~~\_\_\_\_\_~~  
7417 Baltimore Ave. Prelim. Cons.

Takoma Park Historic District

# Prelim. Consultation Plans

↓ Existing Garage ↓

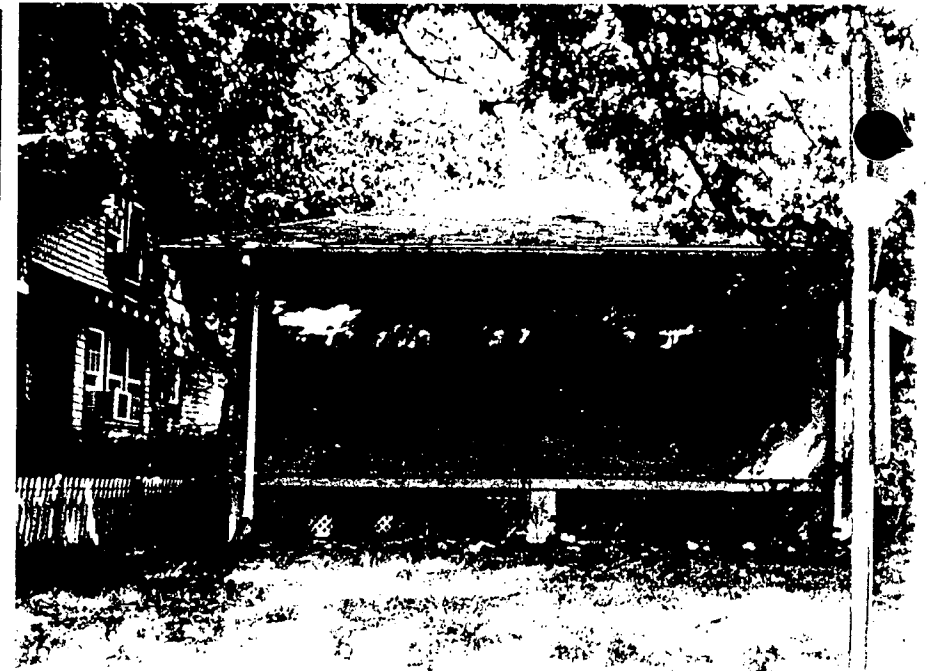
Staff feels that it is inappropriate to demolish the existing garage. The structure is of the same approximate age as the house and should be considered a part of the historic contributing resource. The garage is a one story, one car, frame garage with German siding and asphalt roof and is in need of only minor repair.

WEST  
PROPOSED ELEVATION  
SCALE: 3/16" = 1'-0" 7417 BALTIMORE AVE

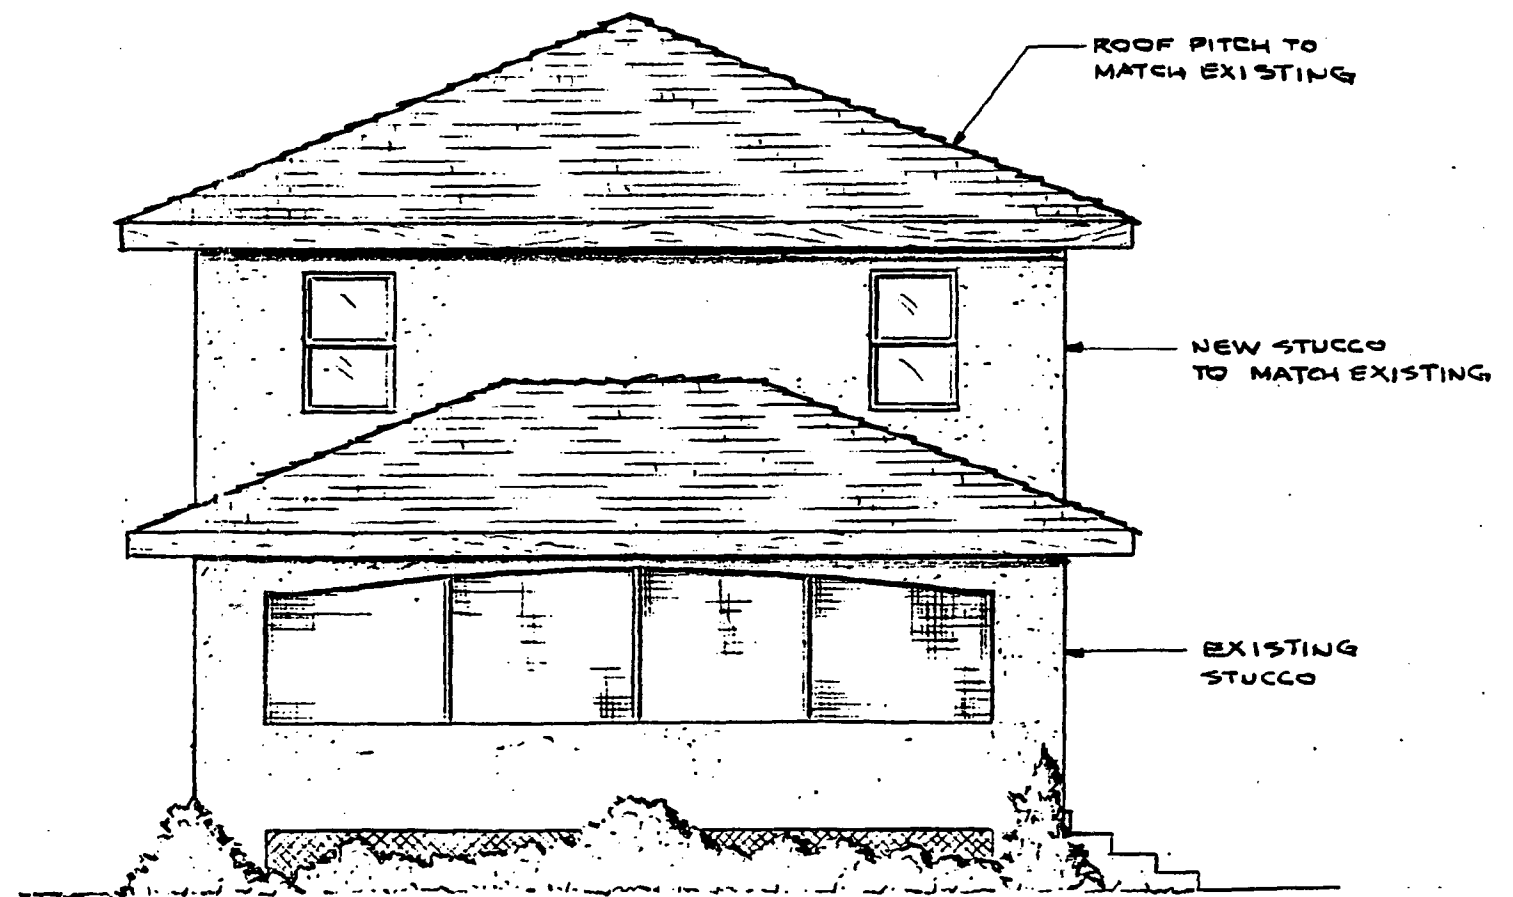
From the Front or West Elevation, the addition as currently proposed does not differentiate from the historic fabric enough to be recognizable. Furthermore, the proposal destroys the horizontal emphasis of the resource and creates a vertical appearance that effectively changes the architecture of the house from the Prairie style to something reminiscent of an American Four-Square. The Guidelines for Contributing Resources as found in the Takoma Park Amendment to the Master Plan for Historic Preservation state:

Because it is important to preserve the dominant architectural style of the historic resource and because the proposed changes are highly visible from the street, staff feels that the applicant should re-design the second story and strive for a more horizontal effect to conform to Prairie style architecture. This might be achieved if the addition was recessed from both the sides and front of the existing structure, thereby setting it back to preserve and reveal the historic roofline. This recessing of dormers and second stories is a common feature of Prairie style structures.

- 1) The addition should be re-designed to make it more compatible with the horizontal quality of the historic resource, possibly by recessing it and extending the overhead portion to the ground.
- 2) The applicant should not demolish the existing historic garage, but instead preserve the structure, and if necessary, find a new use for it such as a storage building.
- 3) Either the carport or garage should be eliminated.
- 4) Any new garage or carport should be detached from the house with ample space in between the structures.

PROPOSED SOUTH ELEVATION

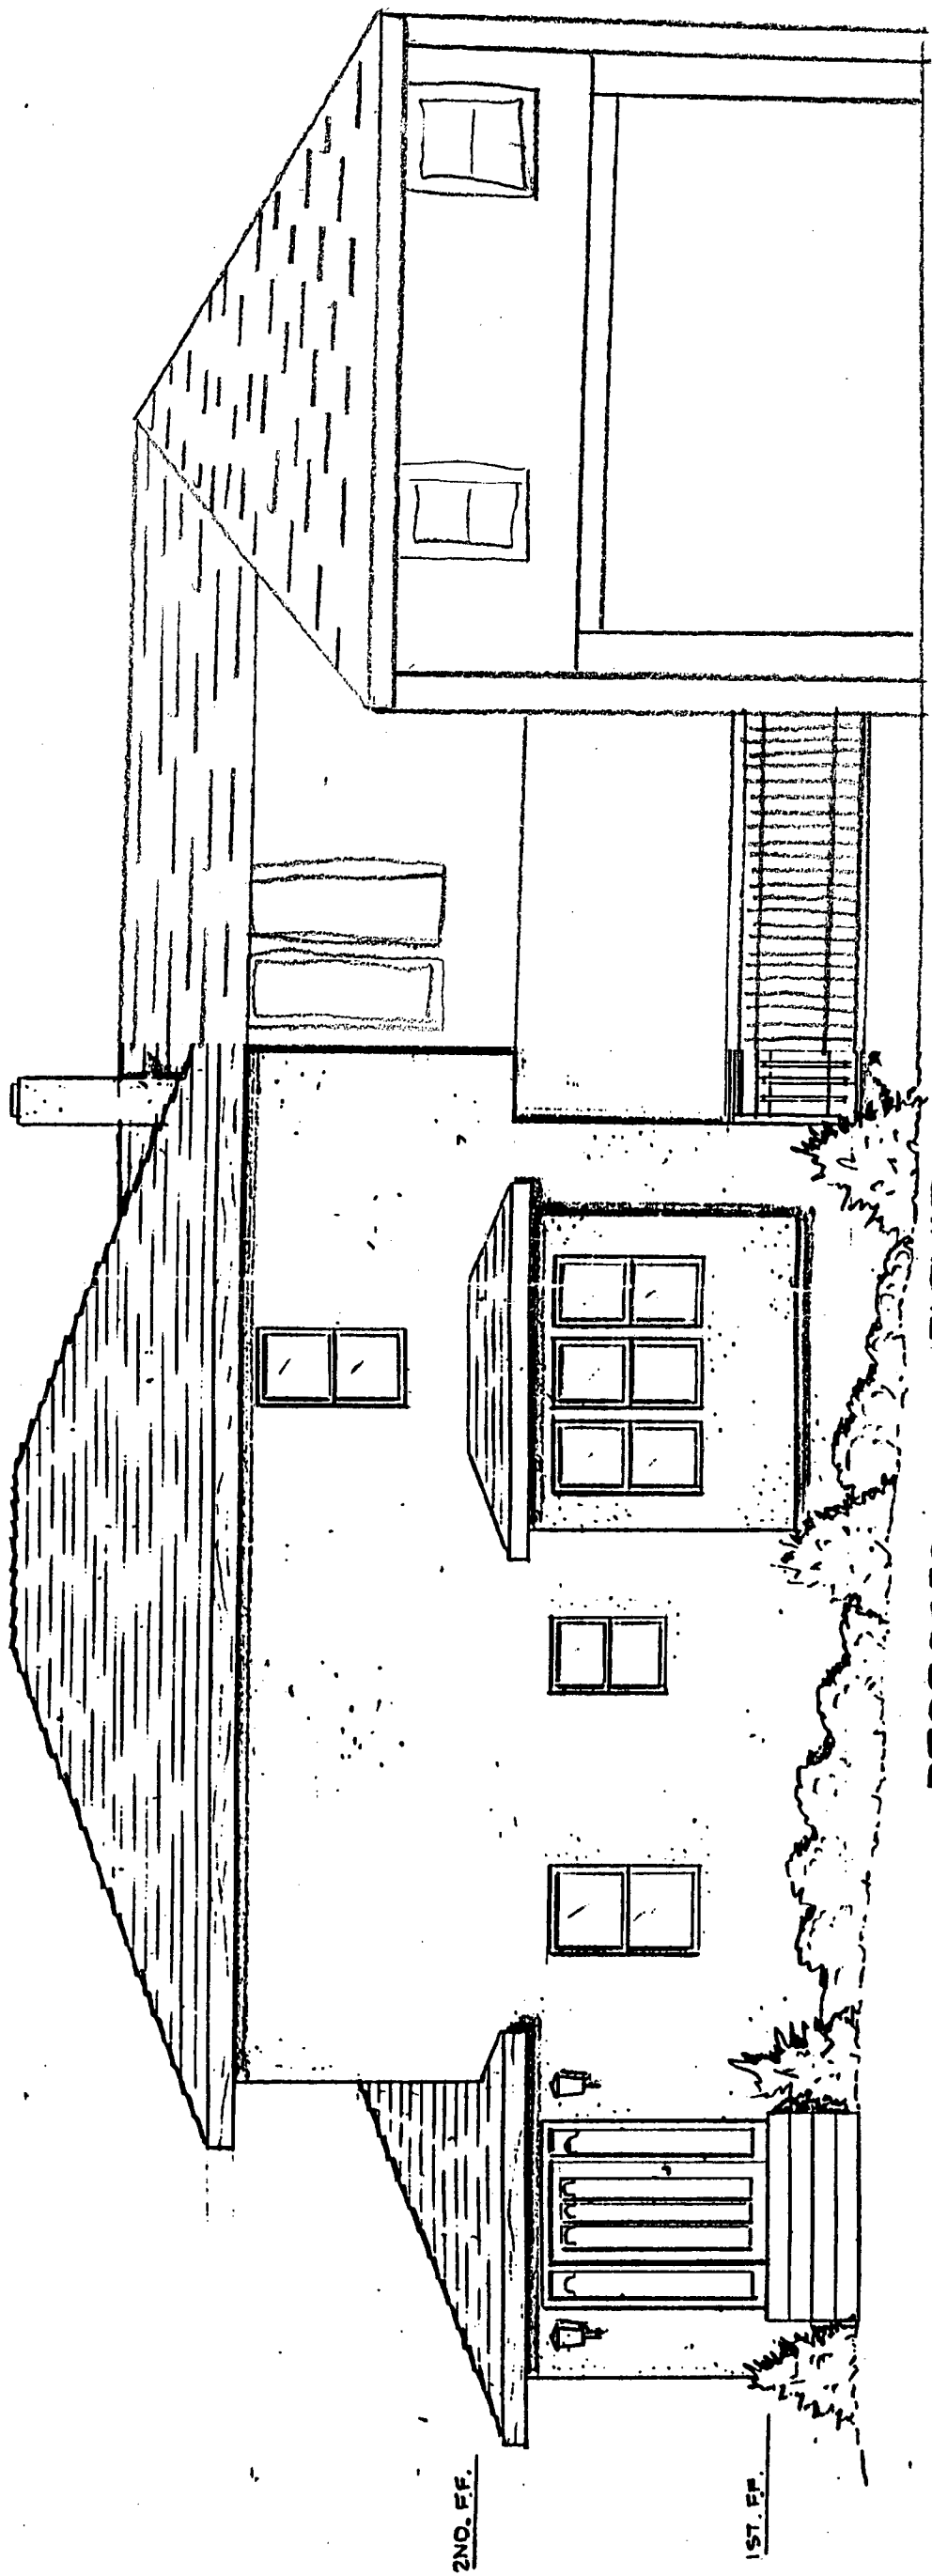
Staff feels that the bridge-like appearance of the proposed South Elevation is incompatible in massing with the original structure and destroys the intent of the Prairie style architecture, which is to create a low to the ground, horizontal feeling. The South Elevation directly faces Cleveland Avenue and is highly visible from the street. Staff recommends that the applicant re-design the addition to eliminate the bridge-like structure. Perhaps this can be done by extending this part of the addition to the ground. This, along with the recess of the addition on the front and sides would make the addition more compatible with the historic resource and with surrounding historic resources.
